Safety Defect and Noncompliance Report Guide for Vehicles

PART 573 Defect and Noncompliance Report

On December 6, 2013 Hino Motors Sales U.S.A., Inc. decided that (a defect which relates to motor vehicle safety) exists in the motor vehicles listed below, and is furnishing notification to the National Highway Traffic Safety Administration in accordance with 49 CFR part 573 Defect and Noncompliance Reports.

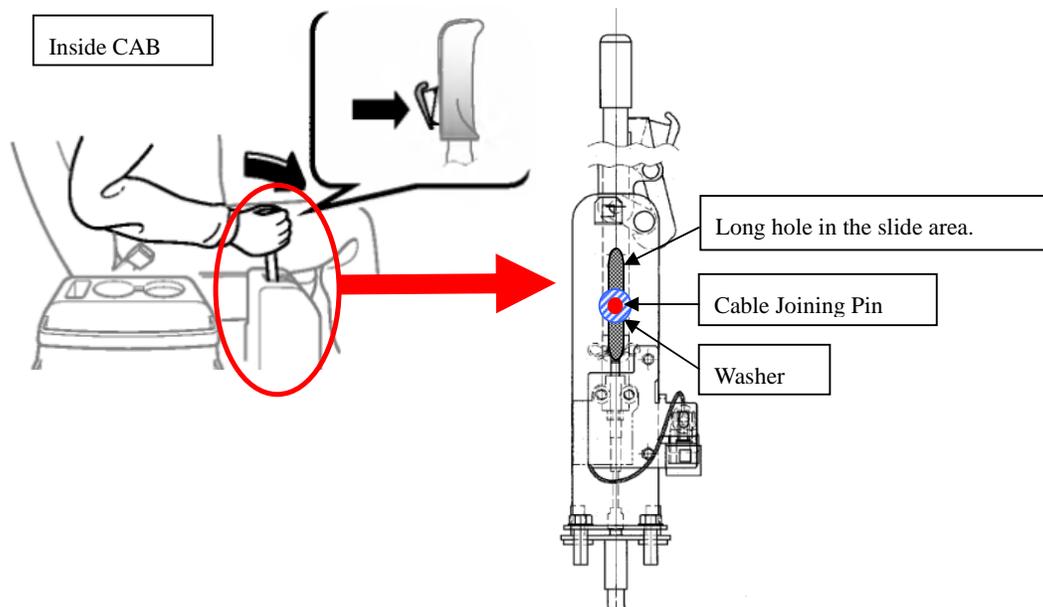
When the parking brake lever is pulled, the washer fixed to the cable joining pin of the parking brake lever can become stuck in the worn and enlarged “long hole” in the slide area. Please refer to the illustration below for details.

The washer fixed to the cable joining pin can become stuck in the worn and enlarged long hole when the parking brake lever is pulled. This situation may prevent the parking brake lever being pulled to its full stroke, leading to the application of insufficient brake force. In the worst case situation, vibration can cause the washer which is stuck in the worn and enlarged long hole to come off, releasing the parking brake lever and resulting in the vehicle moving.

Install a new washer with a larger diameter than the original washer.
